Service
Division
Bulletin

Bulletin Number 19-80

Subject: Shoulder Bolt - Model 93632 Jack

Part Number
231589

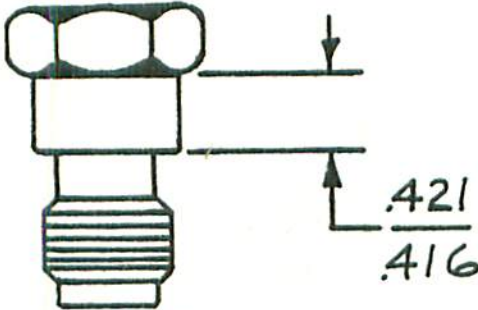
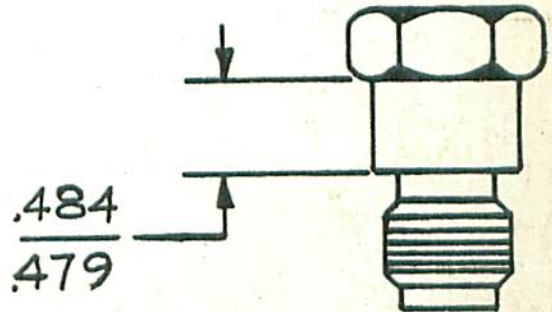
The shoulder bolt for our 1½ ton capacity service jack Model 93632 has been changed. The shoulder bolt used on our current design series "F", "G", & "H" is not interchangeable with the one used on previous production series. Note the drawings below:

The only dimension change is shown on the drawings.

Precautions should be taken to be sure parts in your stock are properly identified. Proper fit to the jack chassis is important and use of the wrong part could cause problems on your jack repairs.

Model 93632
Series - "F", "G", & "H"
Also - 93630 "B", "C", & "D"
93633 "D", & "E"
93716 "D"

Models - J122 all series
93632 - "A" thru "E"
Plus all other applications
